STAFF RECOMMENDATION

816 Shelby Avenue

February 21, 2018

Application: New construction – infill and outbuilding

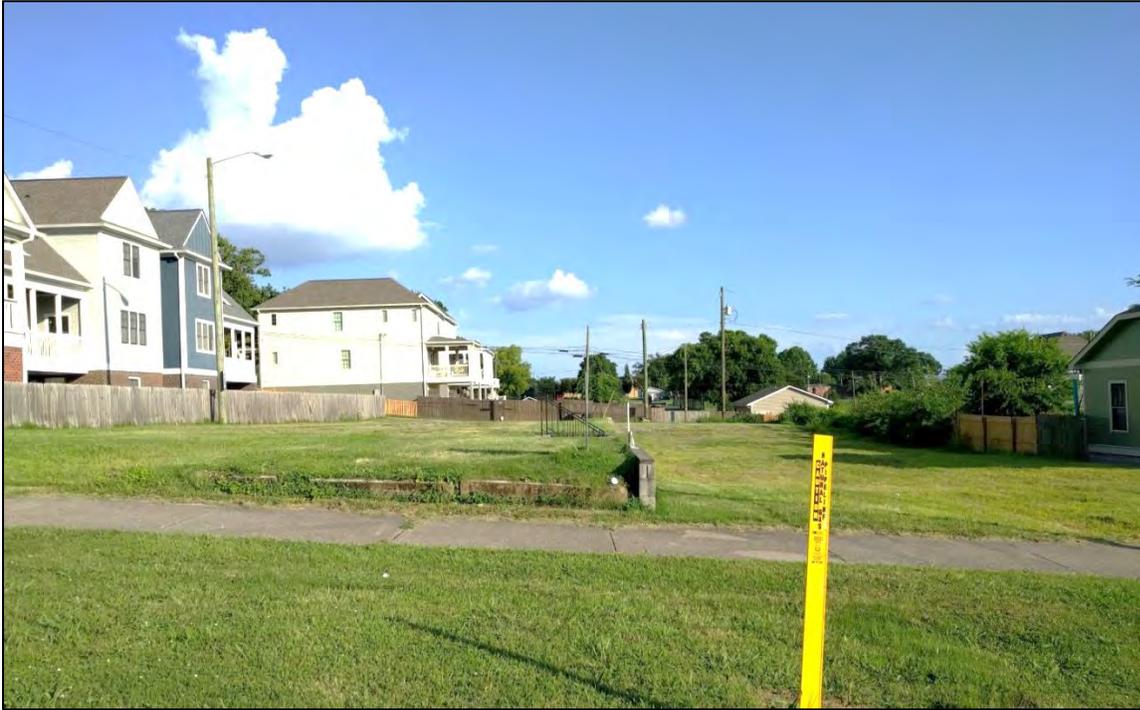
Design Standards: The materials, proportions, and overall character of the accessory structure will be similar to the principal building. The roof will be hipped with a 7:12 pitch, compatible with the forms and pitch of the principal building as well. The outbuilding will have two two-bay garage doors facing the alley, not visible from the right-of-way. Staff finds the design of the proposed outbuilding to meet section III.B.2.h.1 of the design guidelines and section 17.16.030 of the Metro Code regulating Detached Accessory Dwelling Units.

The primary materials are common and generally appropriate, however Staff recommends as a condition of approval that more information shall be provided prior to receiving a permit, including brick color, roof color, as well as the window and door selections and the material of the and paved parking area, walkways, and any appurtenances. With those items to be administratively approved, Staff finds that the known materials would meet section III.B.2.g and IV.2.h of the design guidelines.

1 FRONT - SHELBY AVE.
A-3 1" = 10'-0"

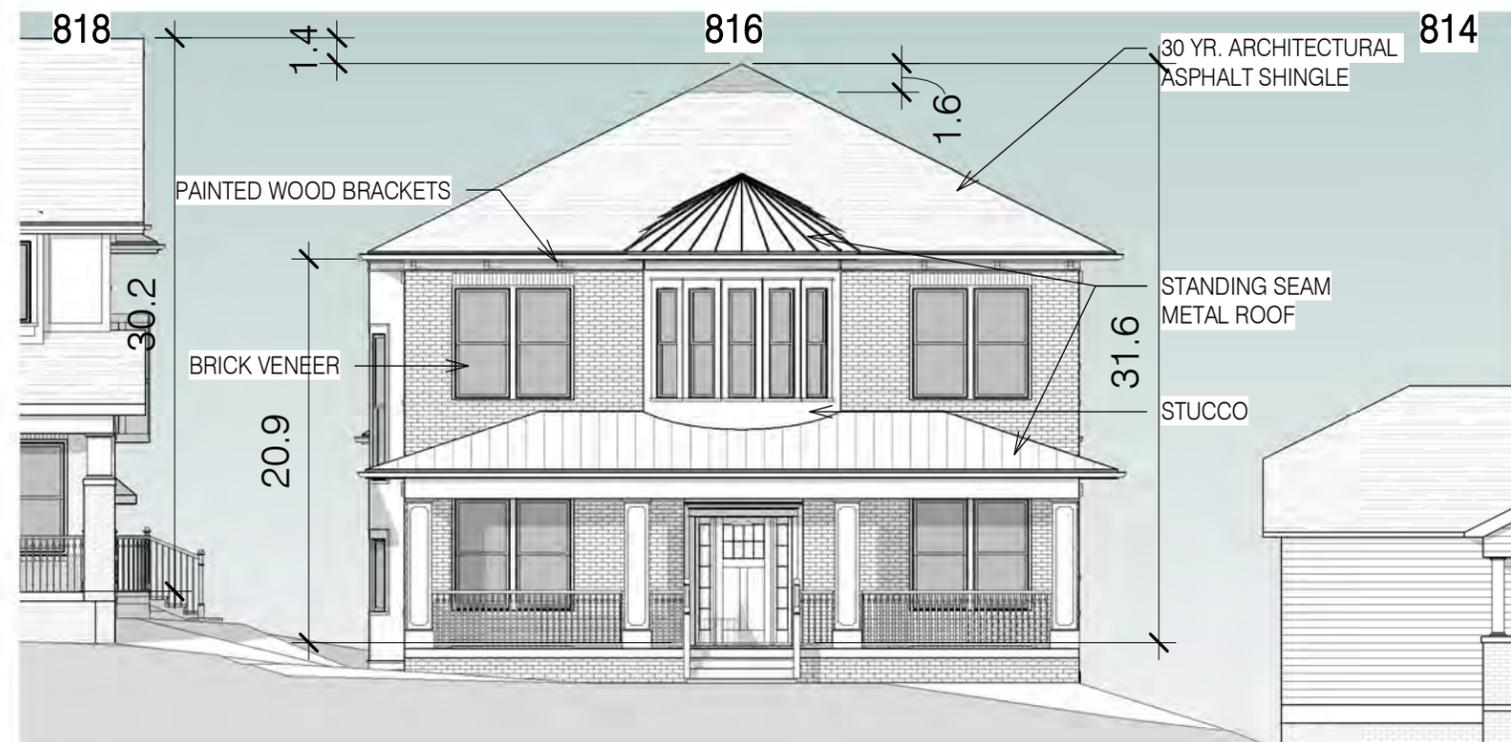
In the center of the upperstory of the front façade there will be a semi-circular bay projecting three feet (3') over the porch. Staff finds that the scale of this feature is not compatible with historic houses in the area. In July 2017, the Commission expressed concern about a similar round bay overshadowing the scale of the main front entrance, which should be the dominant feature of the facade. There are examples of small rounded bays and turrets on historic houses in the area; however, the scale of the proposed projection is larger than is typical of a projecting bay. Staff recommends that the depth of the bay be reduced to two feet (2') at its deepest point to be more in keeping with historic examples.

Orientation: The primary facade of the proposed infill will face Shelby Avenue directly, in the same plane and manner as the surrounding historic buildings, with an eight foot (6') deep full width porch. The plans do not show there to be a paved walkway connecting the front porch to the street as is typical of the historic context. With a condition that there be a front walkway, Staff finds that the orientation of the project meets section III.B.2.e of the design guidelines.

- The finished floor level is consistent with nearby historic buildings, to be verified by Staff during construction; and
- The depth of the round projecting bay shall be reduced to two feet (2’); and
- Brick color, siding texture and reveal, roof color, and all the window and door selections shall be approved by MHZC Staff prior to construction; and
- A paved walkway shall be added connecting the front porch and the sidewalk; and
- Permanent landscape features including walkways, driveways, fences and retaining walls, lighting, and any other appurtenances shall be approved by MHZC Staff prior to installation; and
- The HVAC condenser shall be located behind the midpoint of the building on a non-street-facing elevation.
